**IN THE MATTER OF
THE APPLICATION OF
CRADDOCK AVENUE PARTNERS
L.L.C. FOR AN EXCEPTION
FOR AN EDWARDS AQUIFER
PROTECTION PLAN**

MOTION TO OVERTURN / MOTION FOR RECONSIDERATION

**Re: Recharge and Transition Zone Exception Request for the Buie Tract
City of San Marcos, Hays County, Texas
Craddock Avenue Partners, LLC, P.O. Box 5555, Austin, Texas 78763
Received on February 10, 2010, by TCEQ Field Operations, Austin
Region 11**

Figure 1. Sensitive Karst Areas (Zara, 2008)

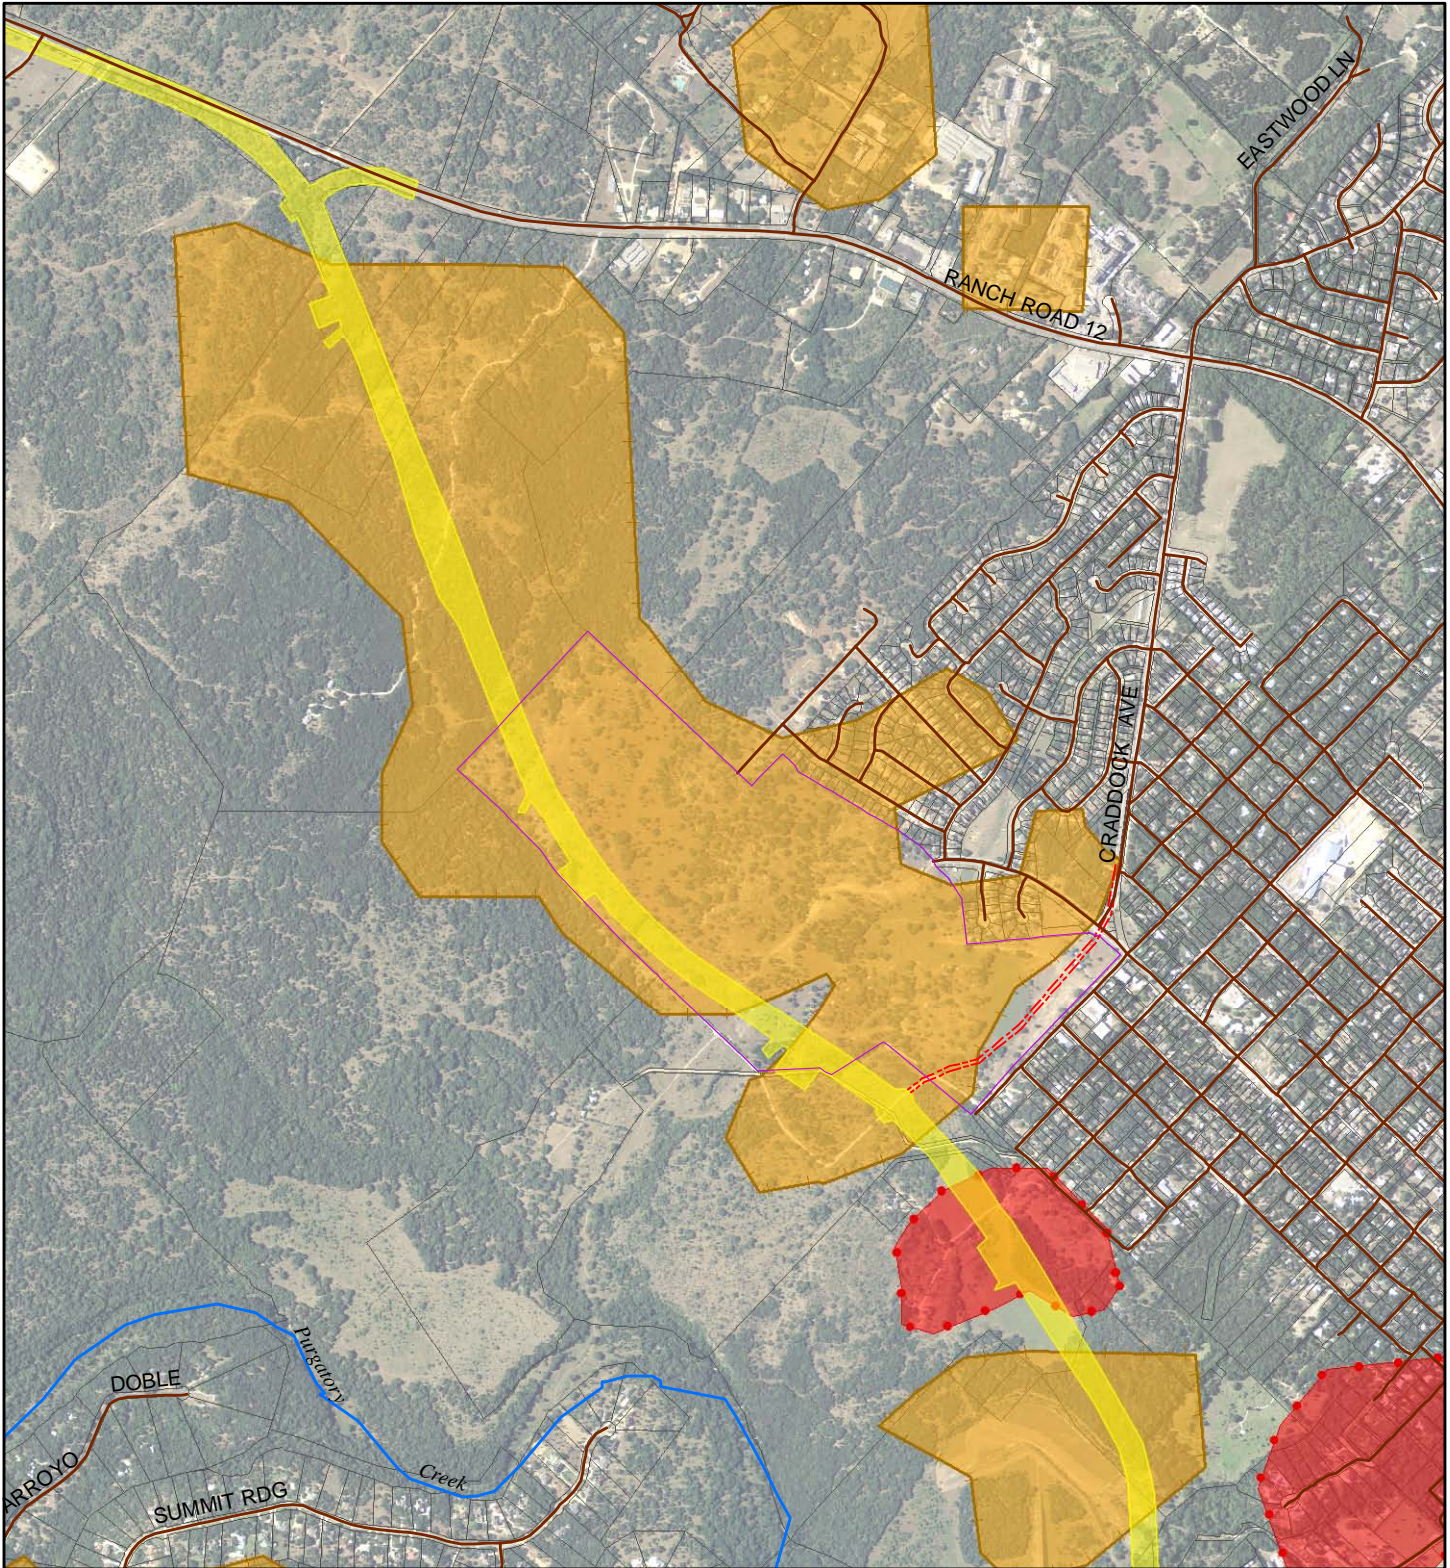
The Buie Tract completely overlies a particularly sensitive area of the Edwards Aquifer Recharge Zone (EARZ). Figure 1 shows that the Buie Tract lies completely within a limited area of generalized karst features, which is delineated by Zara (2008) as one of the most sensitive karst areas in Hays County. TCEQ requires any developer in the EARZ to submit a final GA and a WPAP prior to on-site development activities, in order to avoid non-point source contamination and protect sensitive aquifer resources. Despite extensive prior site preparation within a highly sensitive recharge zone, no WPAP has yet been submitted for the Buie Tract.

Figure 2. Buie Tract: Grimshaw (1976) Faults
Superimposed on Harper's (3-23-10) Site Geology Map (Exhibit F)

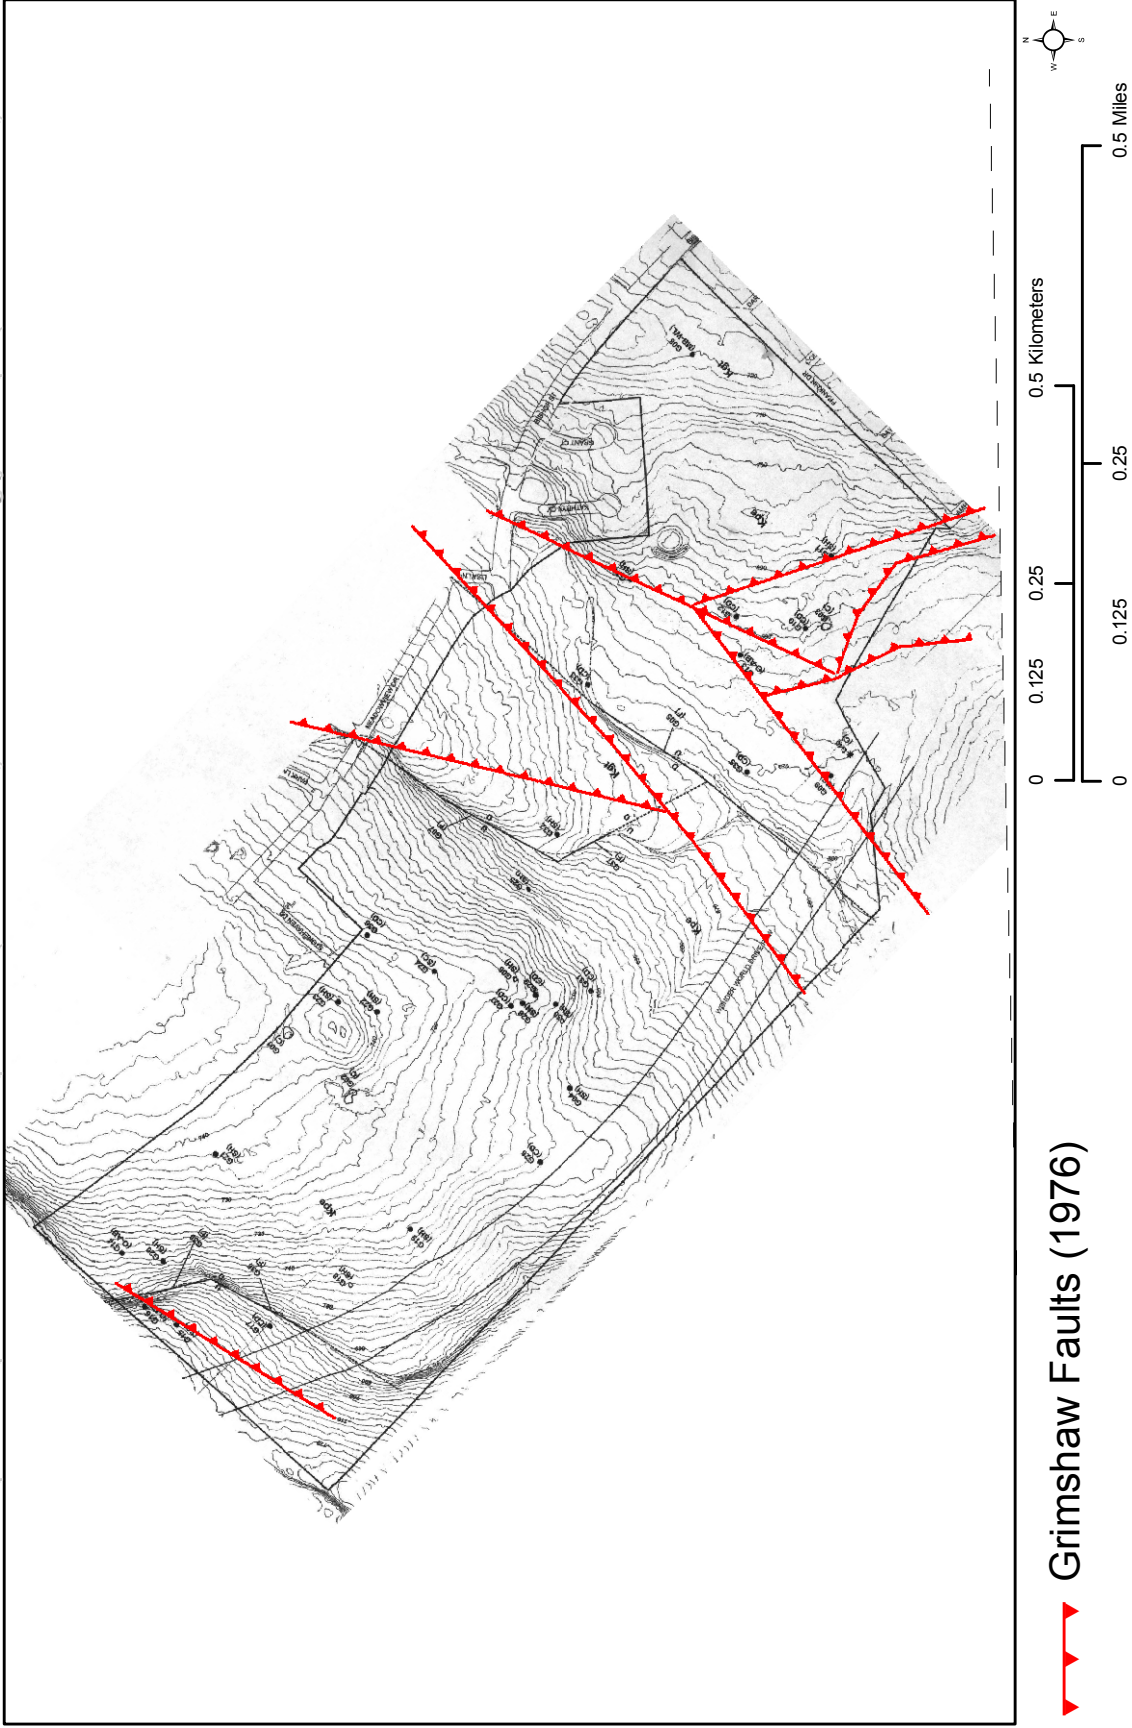
The extensive site clearing on the Buie Tract enhances the visibility of faults. The most accepted geological study for the area, Grimshaw (1976), confirms the existence of a complex of nine major fault segments within the southeastern portion of the Buie Tract. These faults are not depicted in the most recent Site Geology Map (3-23-10) attached to the Exception Request's GA. This complex of major faults is delineated in relationship to this Site Geology Map in Figure 2.

Figure 3. Buie Tract: Faults in the Southeastern Portion of the Tract

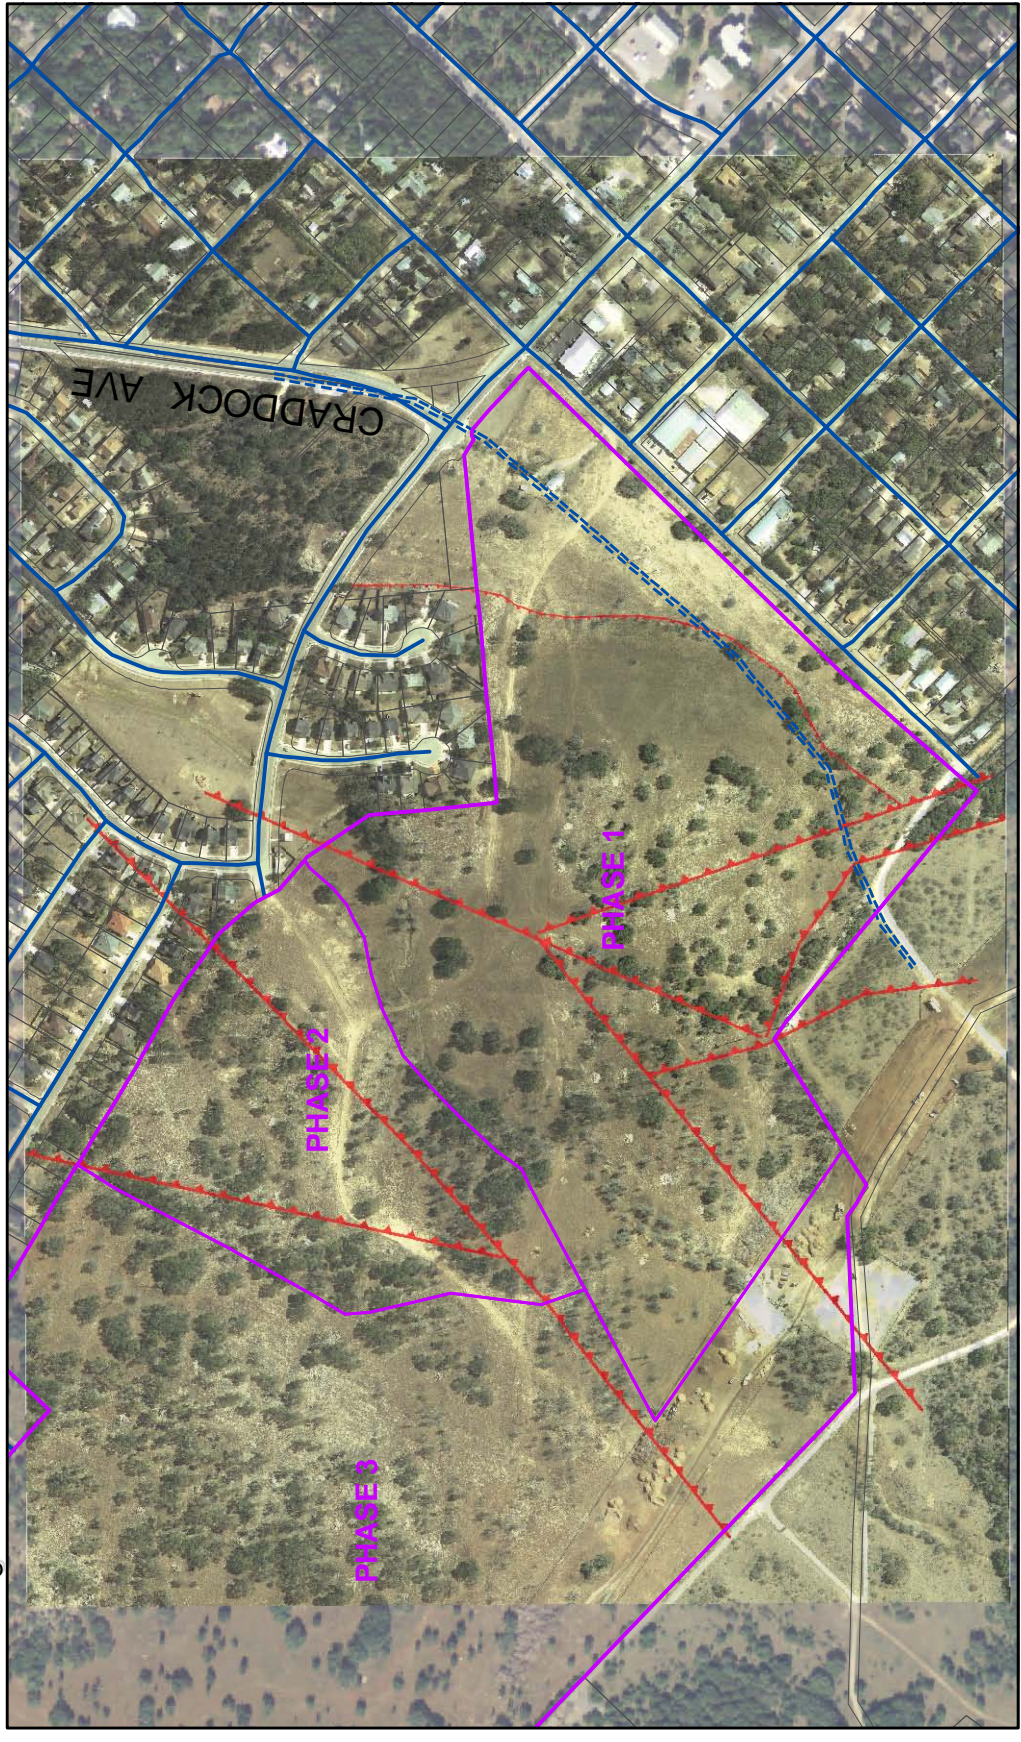
In addition, a more recently mapped major fault is well known by local geologists and geographers east of the above complex of Grimshaw (1976) faults. This important fault is mapped relative to the Grimshaw (1976) complex in Figure 3. Figure 4 provides a higher resolution photograph, in order to show the clear visibility of the more recently mapped fault. Like the Grimshaw (1976) fault complex, the latter fault is well known and highly visible at road crossings and within the trenches currently excavated for the Craddock Avenue Extension on the Buie Tract. In fact, the fault underlies much of this portion of the Craddock Avenue Extension.

Figure 5: Buie Tract: Comparison of Harper (1-12-10: green symbols) versus Texas Speleological Survey (yellow symbols) Geological Feature Locations

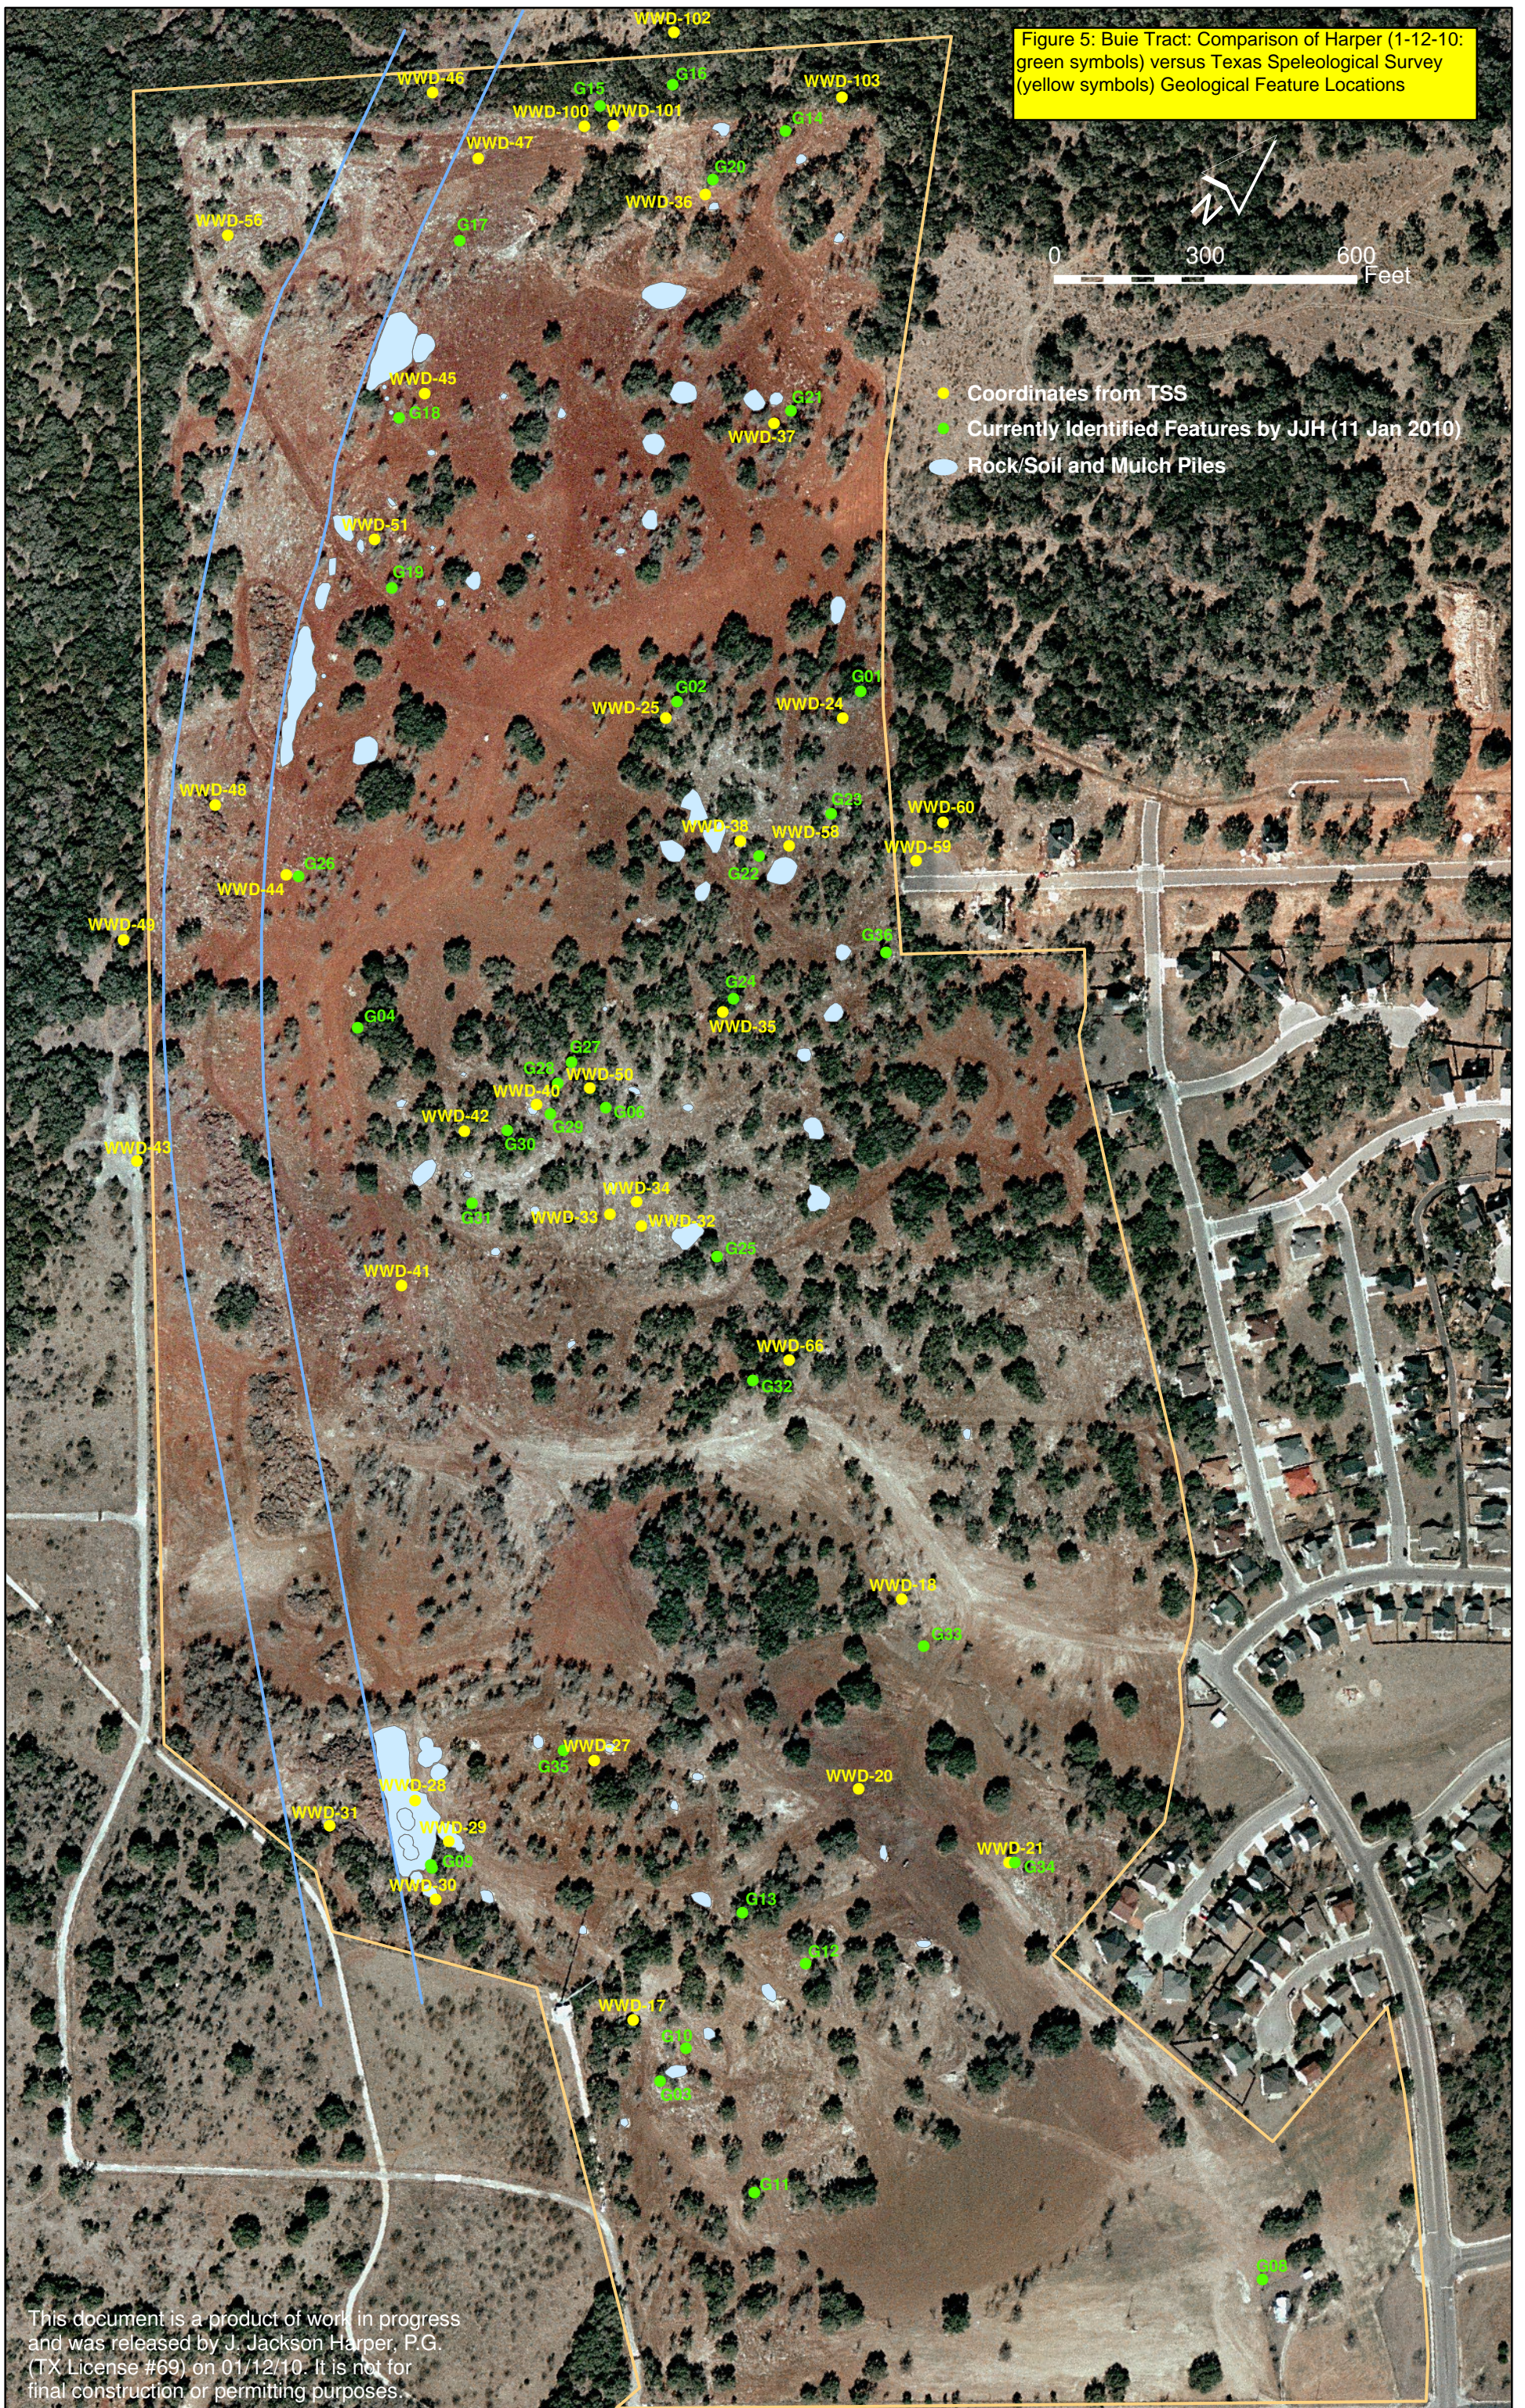
Provided by Jerrett Kramer of the TCEQ, Figure 5 presents a comparison of the geological feature locations found by Jackson Harper (1-12-10) to those found by Veni and Associates

(2003), which were subsequently mapped by the Texas Speleological Survey (TSS). The lack of certainty that all of George Veni's locations were found by Harper is apparent. The original GPS coordinates from Veni (Veni and Associates 2003) for the features his crew found have still not been obtained by TCEQ, the developer's consultants, or TSS.

Veni reports (email dated February 15, 2010, from Veni to Jerrett Kramer, TCEQ investigator) that the TSS coordinates are inaccurate due to a skewing of Veni and Associates' (2003) original coordinates during data processing by Hicks and Company. As recently offered by Veni in this same email, his original coordinates should be obtained to accurately address the still unresolved disparities between the cave and karst feature locations reported by Veni, TSS, and Harper. In this manner, the GA may be revised to finally resolve some of the caves, faults, and recharge feature, which were previously found but not definitively relocated.
